**Consideration of Radiation in
Hazardous Waste Produced from
Horizontal Hydrofracking**

*Report of E. Ivan White
Staff Scientist for the
National Council on Radiation Protection*

Figure 1: Comparison of Exposure to NORM in Marcellus Shale for Vertical Wells and Horizontal Wells

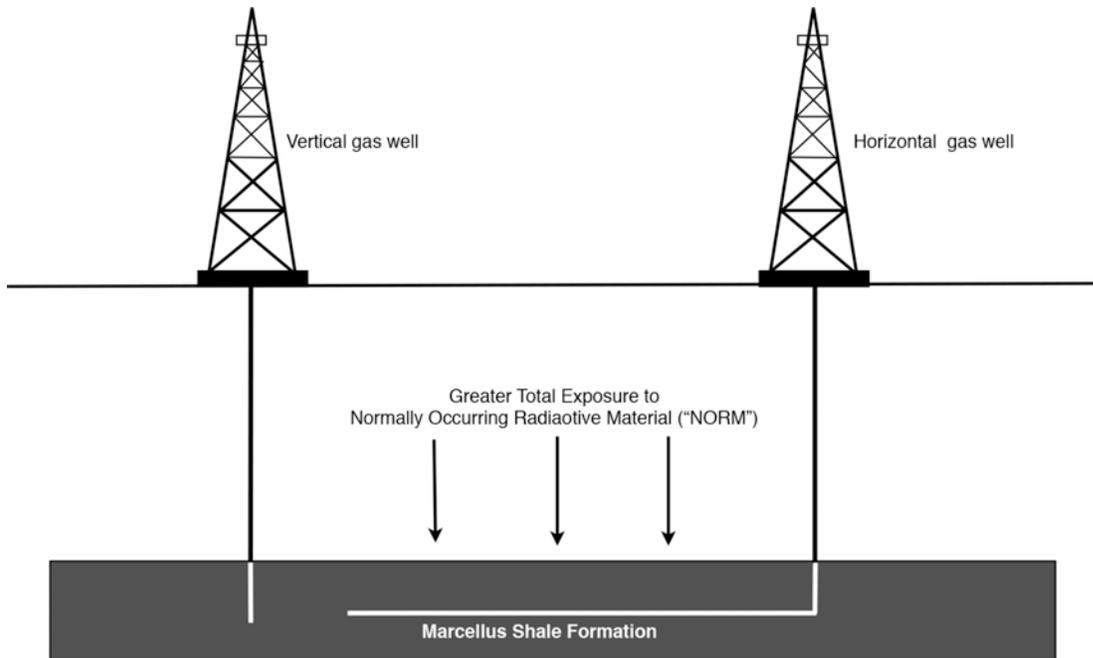
Based on my experience in assessing potential transport pathways for radiation and a review of the DEC's internal report, I find two serious flaws that must be addressed and corrected prior to any final determination related to hydrofracking in New York State. The first is that the report examined a very different type of drilling than that which is being proposed. The second is that the authors used RESRAD in a limited way, resulting in faulty conclusions.

The 1999 DEC report examines vertically-drilled oil and gas wells in New York State that have been hydrofracked. This is very different from the *horizontal* hydrofracking currently being proposed for New York State. Vertical wells of the type measured by the NYSDEC are typically 1500-3000 feet deep with minimal penetration into the Marcellus shale formation. Horizontal slickwater hydrofracking wells, on the other hand, reach depths of 6,000 feet before turning horizontally for an additional mile or so. These deeper, longer wells have a much greater overall exposure to the Marcellus Shale formation and the radioactive materials contained within it, and thus an increased likelihood of bringing that radioactivity to the surface. (See Figure 1)

Figure 2: Pathways for Radiation Migration Through Air

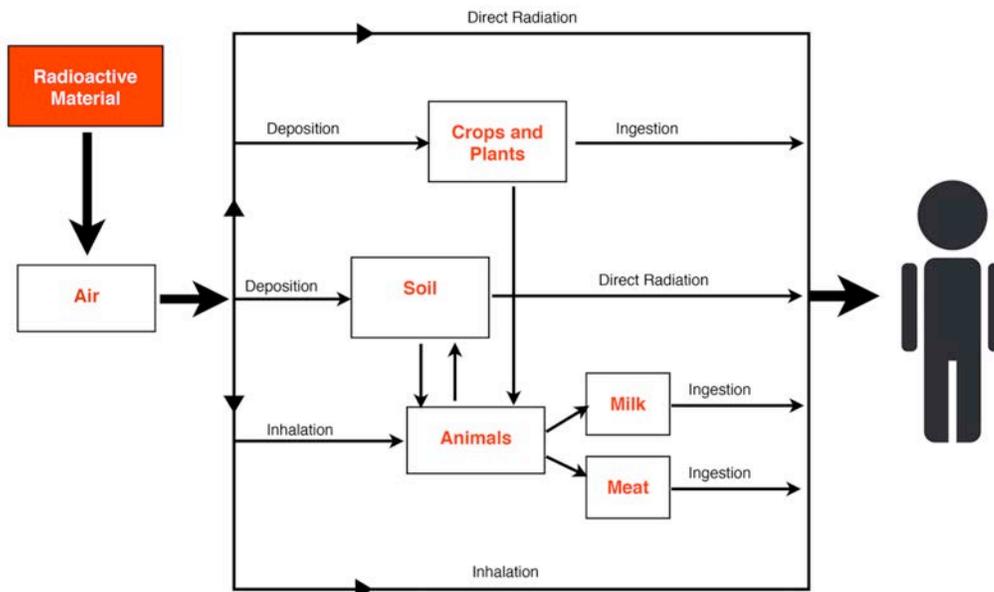
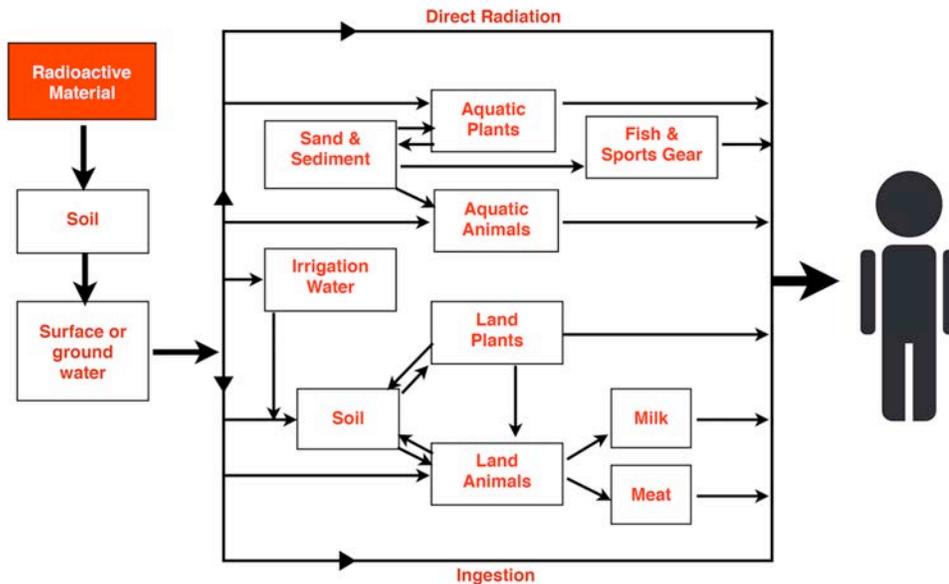
The second flaw is that RESRAD was not properly used to determine **all** of the potential pathways of the radiation. The following diagrams illustrate the potential pathways for radionuclides released into the environment in an uncontrolled manner, in air or in water.

For example, if radioactive wastewater from hydrofracking is spread on a road, there are two possible scenarios involving different pathways.

In one, the radioactive waste is spread on a paved road with a crown. Some of the waste will inevitably run off the road and find its way into a waterway or onto grazing fields or crops with the resulting pathways. The radioactivity in the waste remaining on the road will be resuspended by the traffic into the air with the resulting direct exposure to humans or biota.

In the second scenario, the waste spread on the dirt road is adsorbed by the dirt. When the dirt road dries out, the radioactive waste is resuspended in the dust from the road. The dust particle size and concentration is determined by the weight of a vehicle, the number of tires, and its speed. The dust is inhaled by humans and animals and deposited on the local vegetation, with the resulting pathways as illustrated above.

3. RESRAD was made precisely for situations like this, but it must be used properly to produce valid conclusions. Picking and choosing isolated scenarios and ignoring downstream exposures, as was done in the Report, is not a proper use of RESRAD and renders the conclusions invalid. All of the potential pathways over a span of decades as the hazardous material accumulates and the public's body burden build up must be considered to produce a valid RESRAD conclusion. This applies to both radioactive and chemical waste.
